**SCHINDLER RF1, GK1-W or GK2 SAFETY GEAR ON INSTALLATIONS  
USING I14 GUIDE SHOES**

# Schindler Field Information No.110

## Mandatory Corrective Action

Product Code: 1-11 540 (Car sling/Safety gear)  
Product: I14 Guide shoe  
Title: **I14 Guide Shoe in Collision with Pull Rods of Safety Gear**  
Number of pages: 1 (enter total number of pages after checking in print preview)

Fig. 1

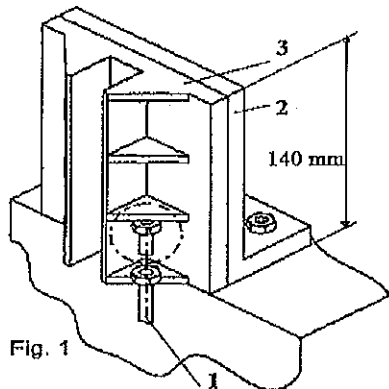
Acceptance tests showed, that the locking nut at the pull rod end can touch the reinforcement ribs of the guide shoe when the safety gear is actuated over the governor lever. (Fig. 1).

**CAUTION: SAFETY COMPONENT**  
**Blocking of the pull rods can cause a safety gear failure**

This problem concerns all installations with I14 guide shoes, Ident No. 582812 (BFK 10) and 582813 (BFK 16), in combination with RF1, GK1-W and GK2 safety gears.

Fig. 2

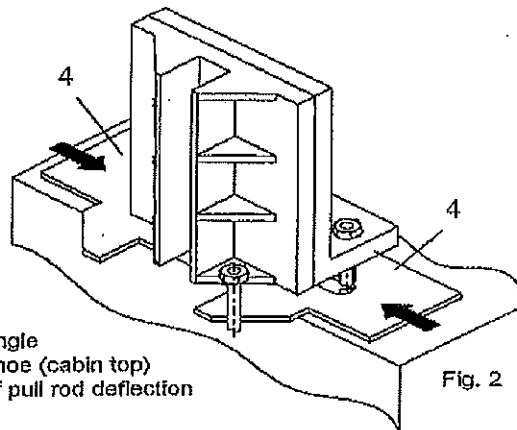
All elevators with I14 guide shoes in combination with RF1, GK1-W or GK2 safety gears have to be equipped with the new pull rod deflections. These metal sheets are to be mounted under the guide shoe on the top of the cabin and keep away the pull rods from the guide shoe ribs (Fig. 2).

- Installations in the field have to be retrofit during the next regular maintenance service.
- For installations outside of the Schindler maintenance portfolio the corresponding KGs have to take the necessary steps for the described rework.

All deliveries from the component factory ECS Mulhouse after June 1997 are already equipped with the new pull rod deflections. At acceptance tests the effectiveness of this part has to be checked.

New deliveries from local factories have to be likewise equipped with pull rod deflections according KA 67295 (worldwide distributed end of July 1997). The concerned KGs are responsible for the realization in their local factories.
